Errata for
Advanced Energy Design Guide for Small Office Buildings
October 5, 2006

Errata for
Advanced Energy Design Guide for Small Office Buildings
November 8, 2006

Errata for
Advanced Energy Design Guide for Small Office Buildings
June 12, 2007

Errata to
Advanced Energy Design Guide for Small Office Buildings
December 31, 2008

Figure 4-1. (EN2) Insulation entirely above deck. Insulation is installed above (a) concrete, (b) metal, or (c) wood deck in a continuous manner.

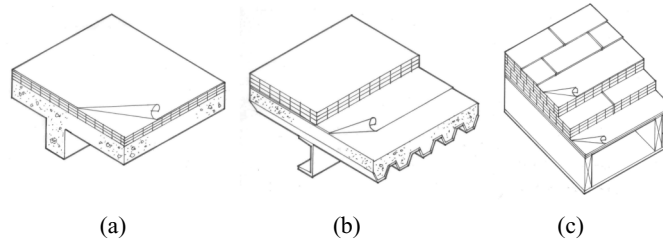
Page 58: The caption for Figure 4-1 is incorrect. Instead of “(a) concrete, (b) wood, or (c) metal” it should read “(a) concrete, (b) metal, or (c) wood.” The corrected figure is provided below.

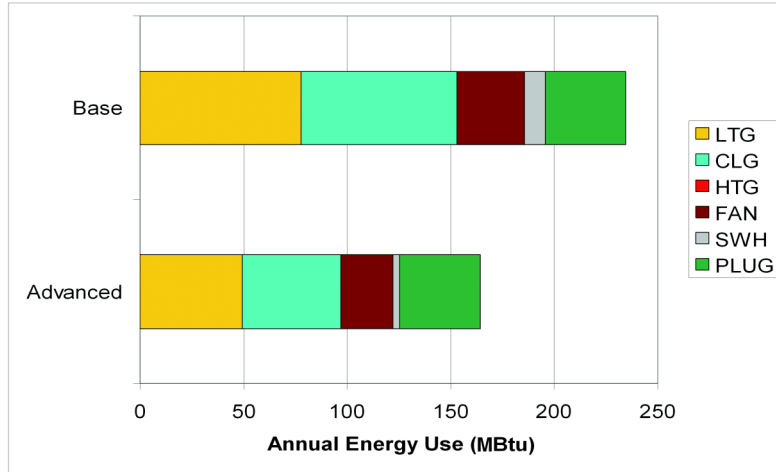
Page 5: The horizontal axes for the bar graphs in Figures 2-2 and 2-3 are labeled incorrectly. Instead of “Annual Energy Use (kBtu)” they should read “Annual Energy Use (MBtu).” The corrected figures are provided below.
